EASTERN CORRIDOR SEGMENTS II AND III (PID 86462)

COMBINED LINWOOD/EASTERN INTERCHANGE & US 50/RED BANK INTERCHANGE FOCUS AREAS ADVISORY COMMITTEE MEETING NOTES

February 14, 2018
May 22, 2018
September 7, 2018
December 12, 2018

Figure EW-2
GRADE SEPARATED INTERCHANGE TO CONNECT
WILMER AVENUE TO WOOSTER ROAD

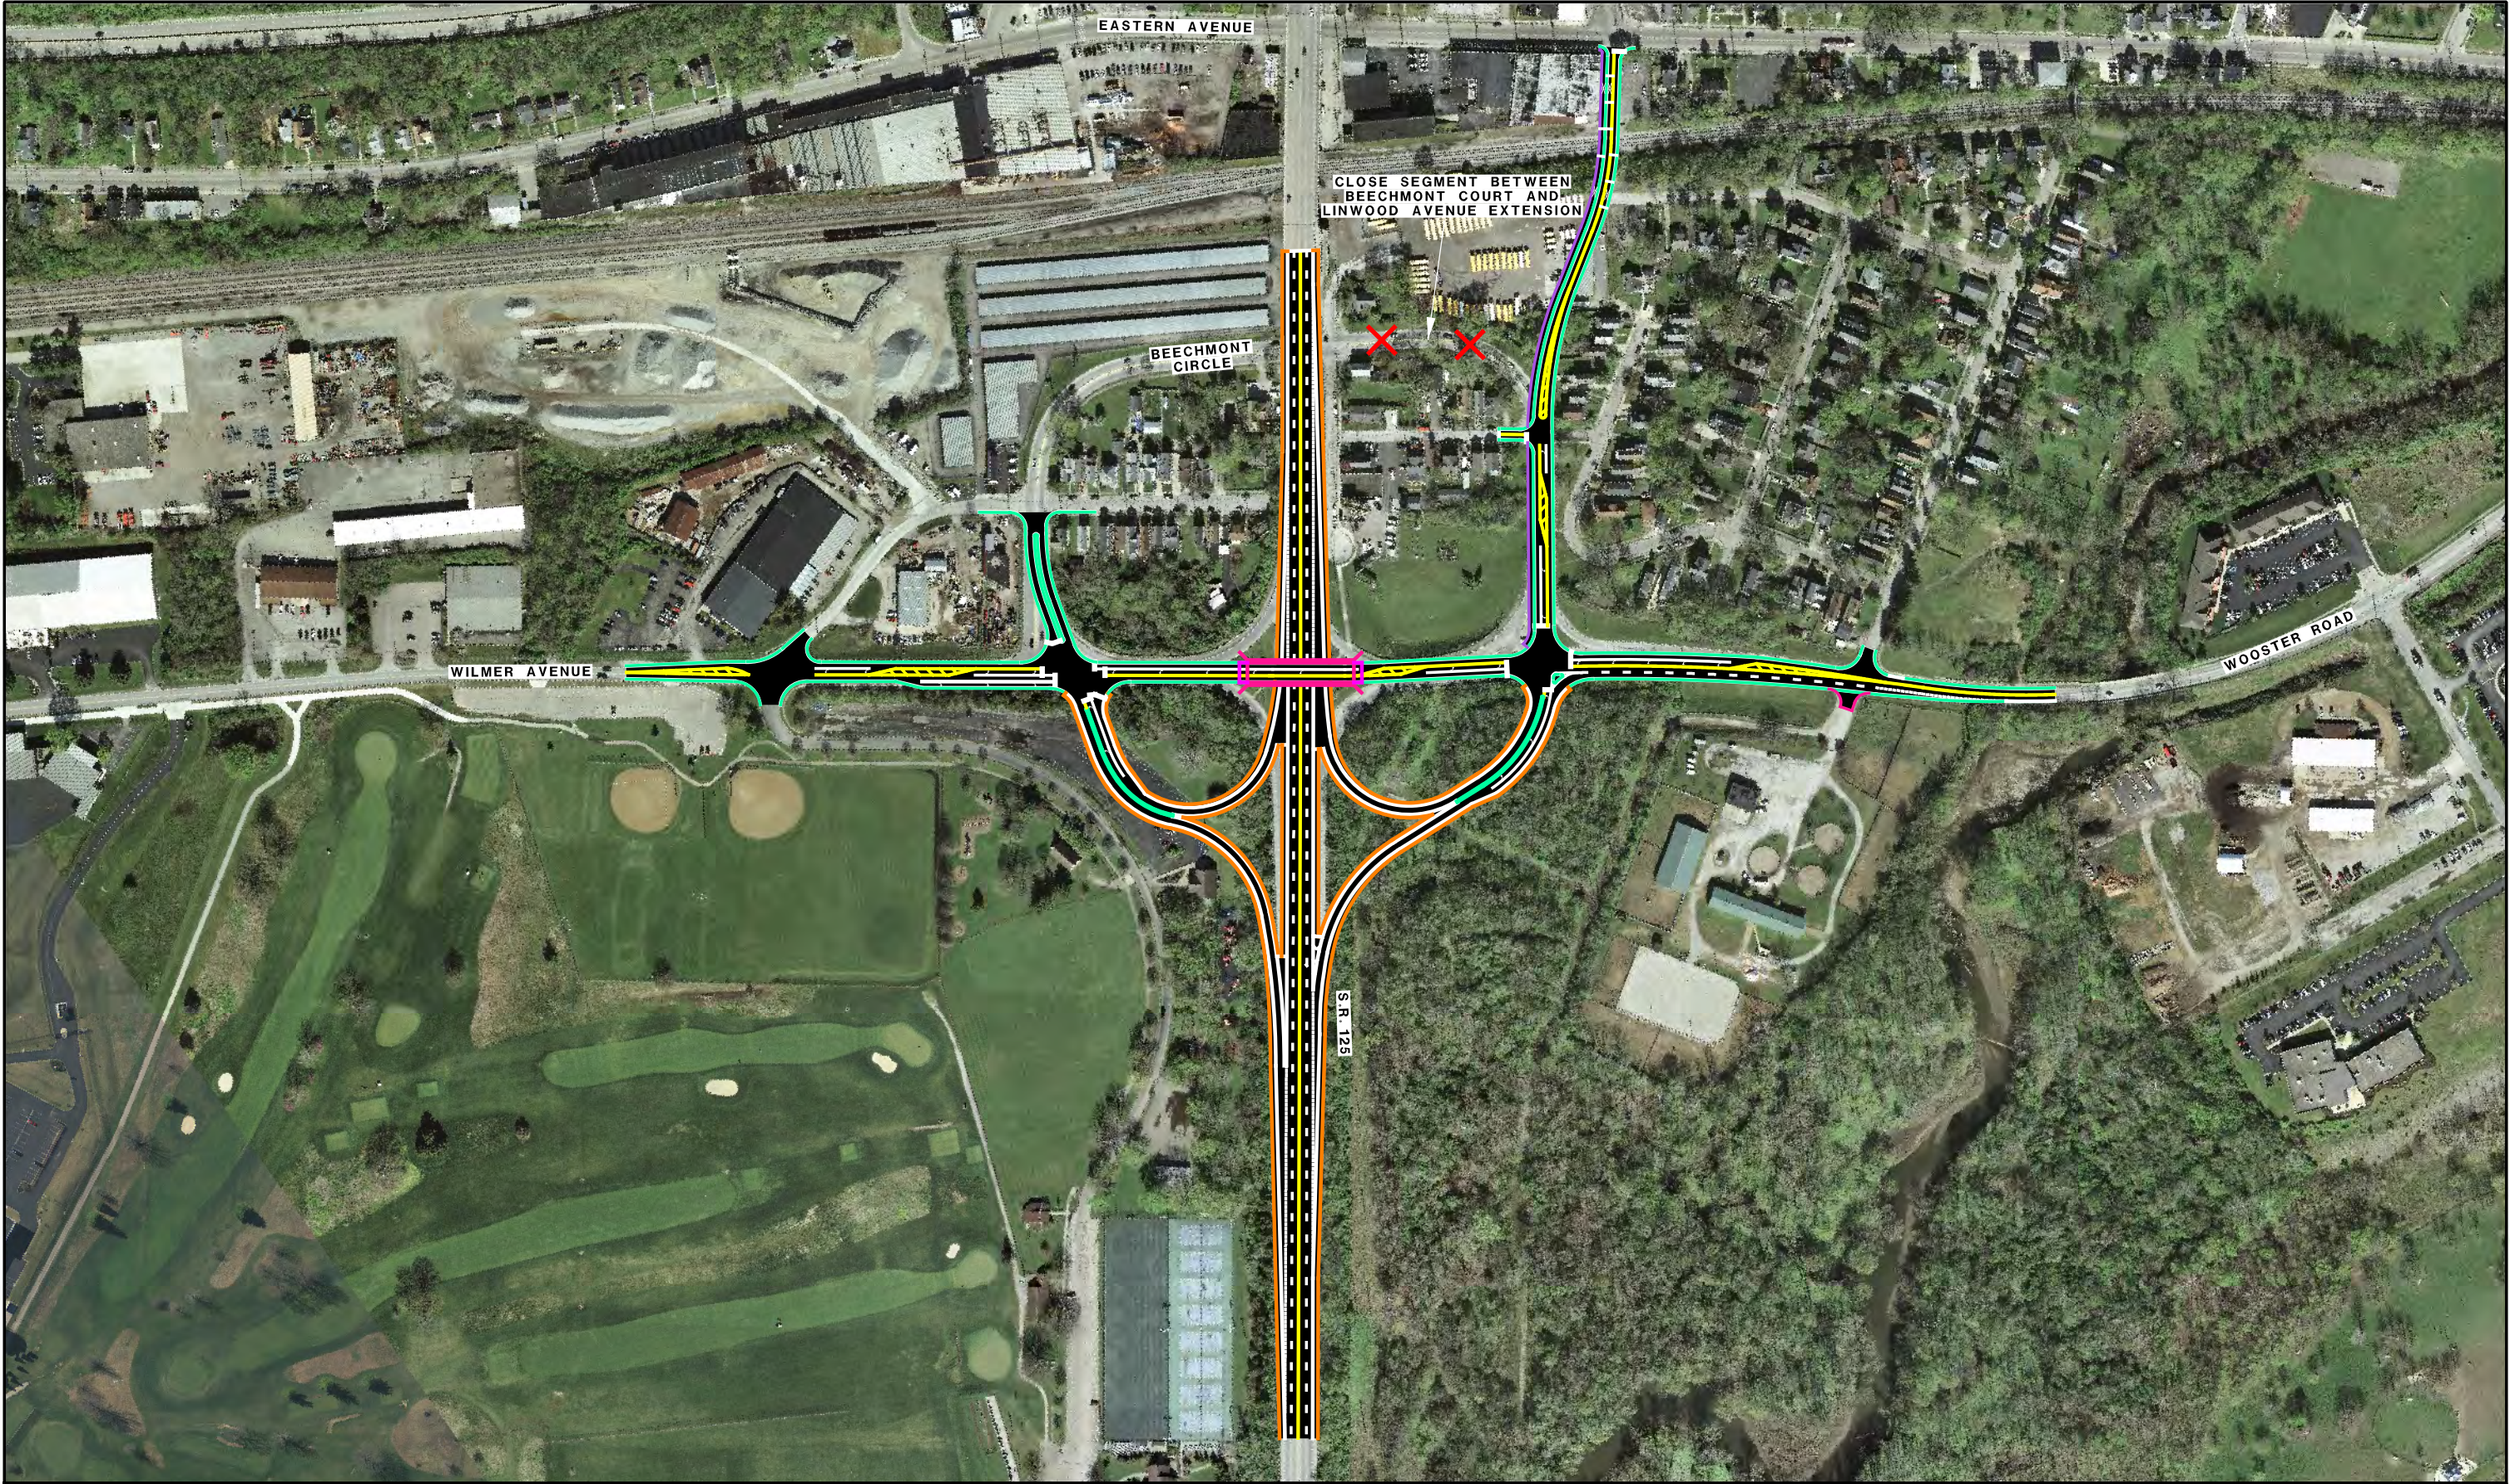
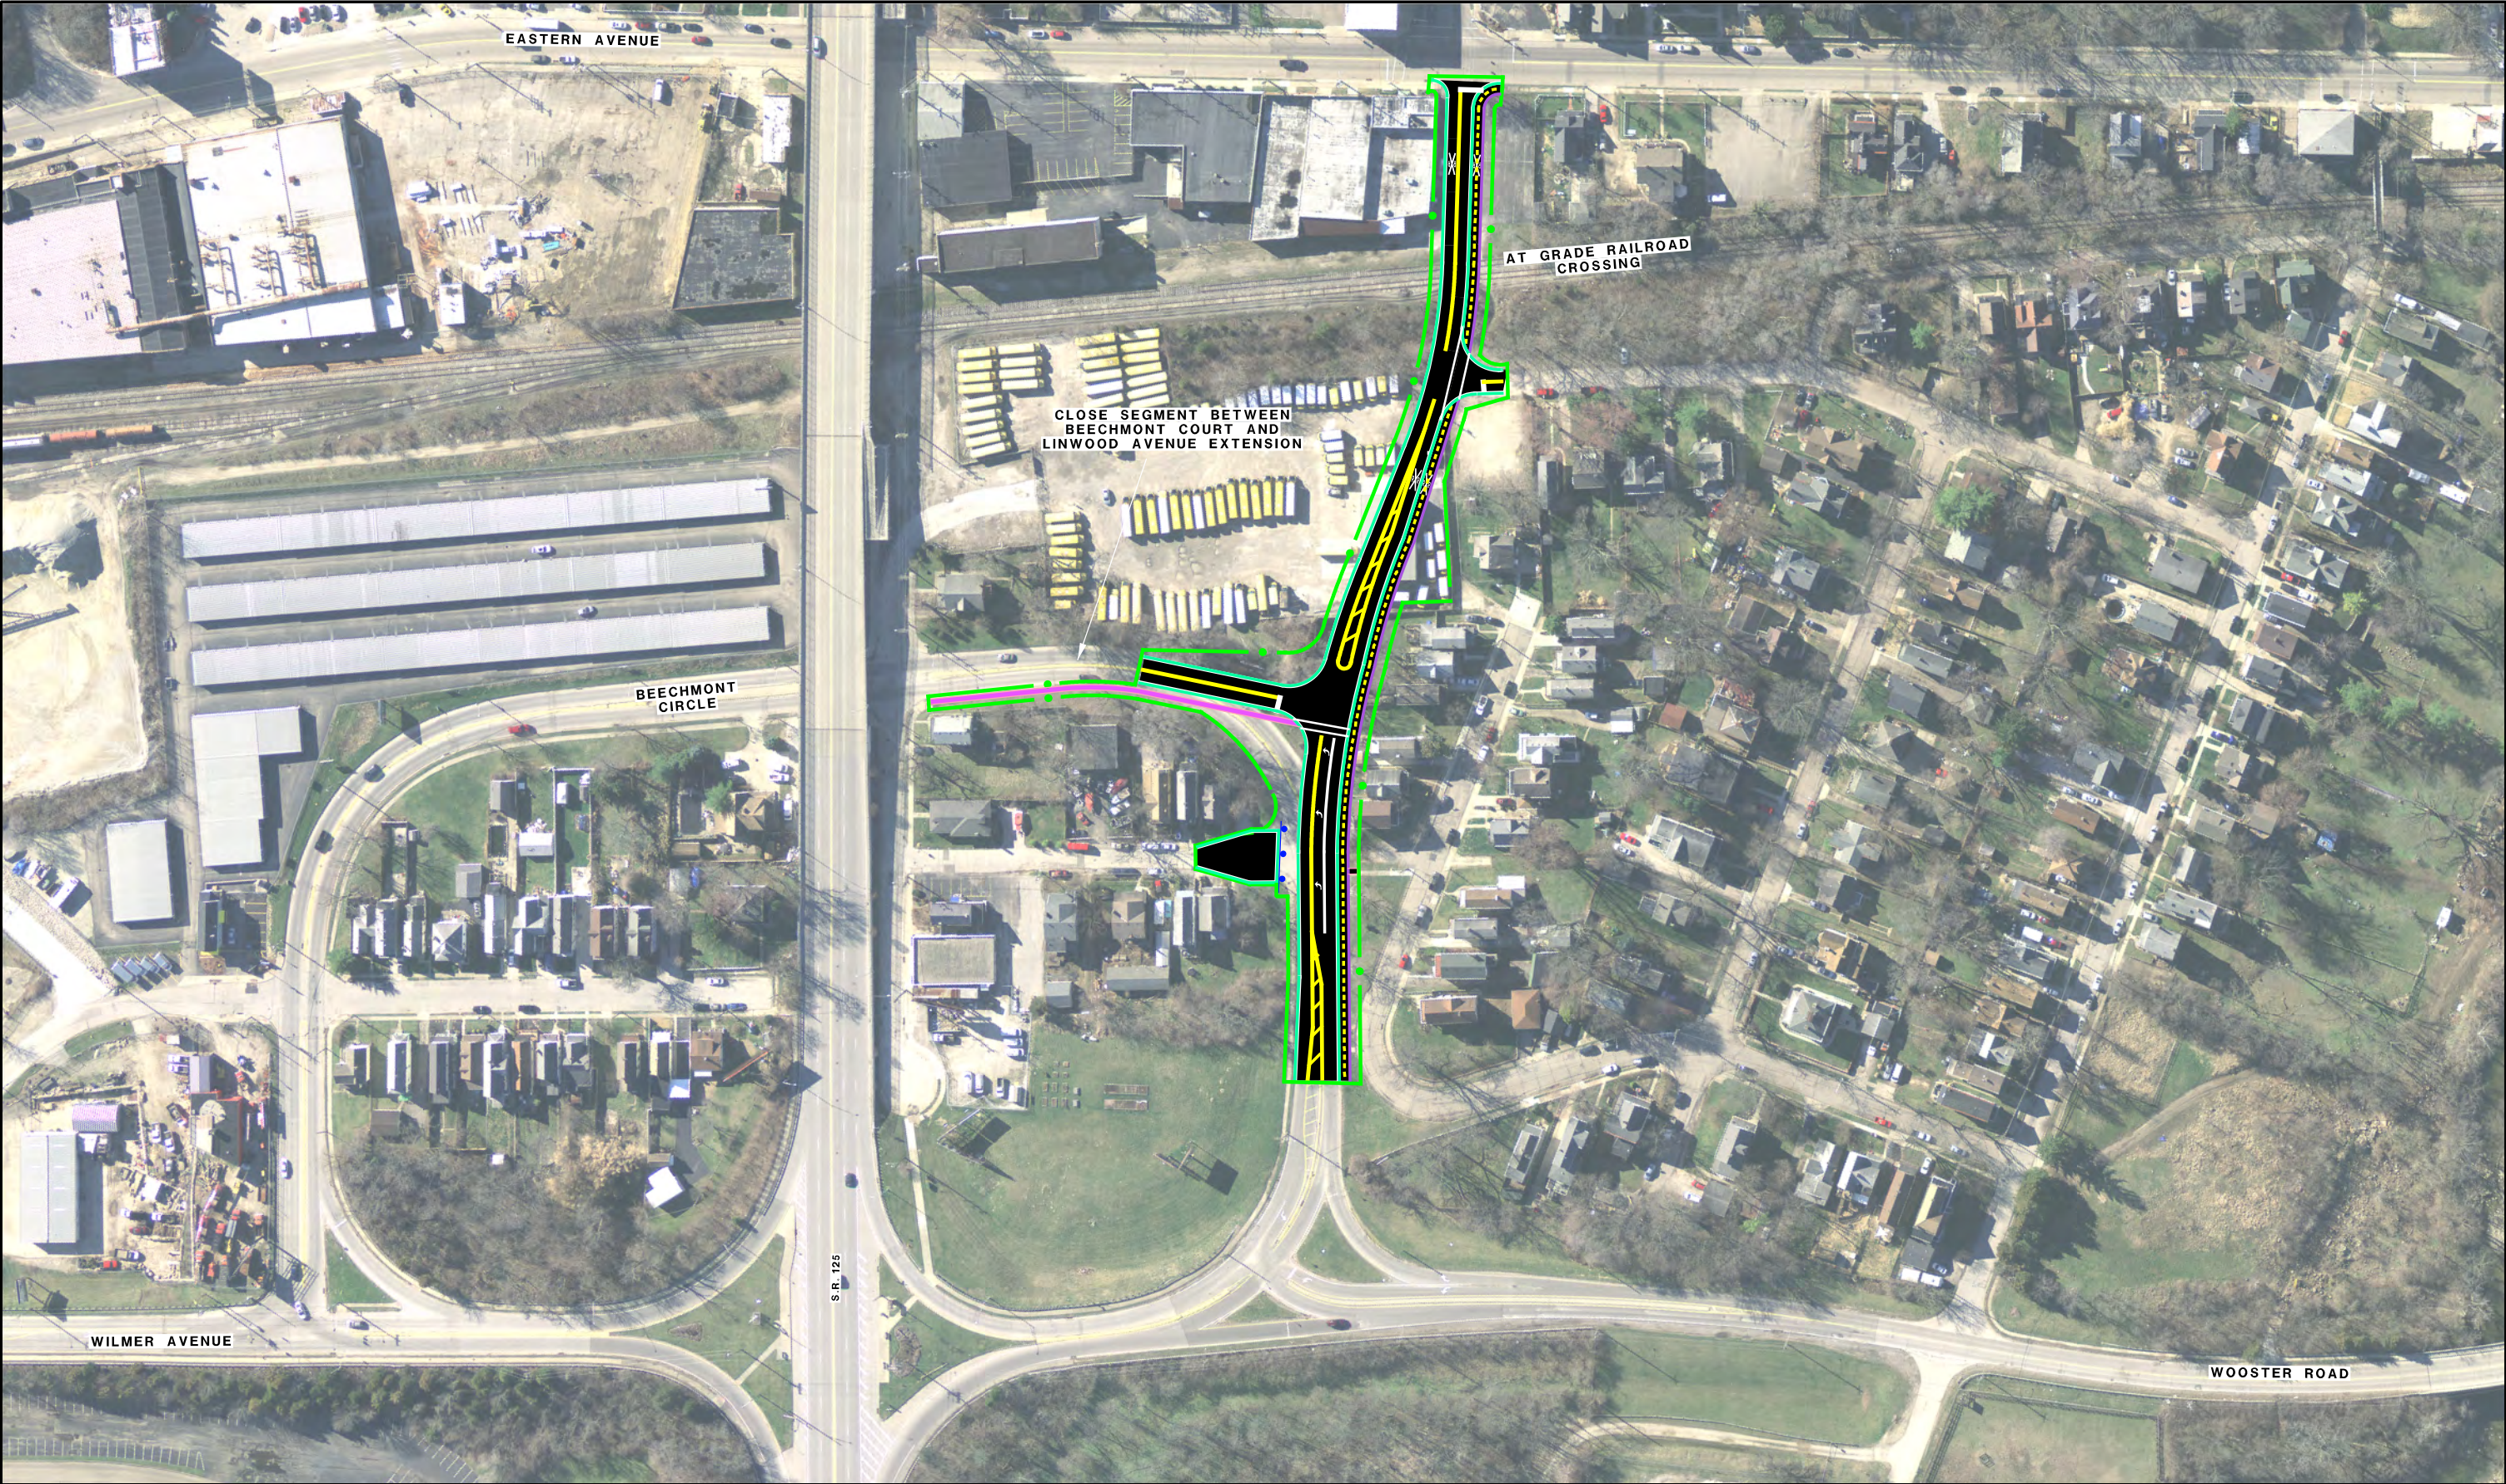
- This concept replaces/adds connectivity lost by closing the deficient ramps from Eastern Avenue to the eastbound US 50 exit ramp (concept X-3a-2); it extends Linwood to the Beechmont Circle and addresses the deficient weave on the eastbound exit ramp to SR 125.
- The concept includes a shared-use path along the east side of the road.
- There would be impacts to the bus company’s operations building and modifications to its parking lot would be needed.
- The concept would require approval of an at-grade railroad crossing and would likely require the elimination of another at-grade railroad crossing elsewhere (per railroad standard practices). If traffic volumes increase, that could be a concern.

- Based on subsequent traffic analysis, this concept is not recommended for further study on its own. However, the concept to extend Linwood is included with Concept X-2b-2a and works well.

RECOMMENDATION: NO FURTHER STUDY
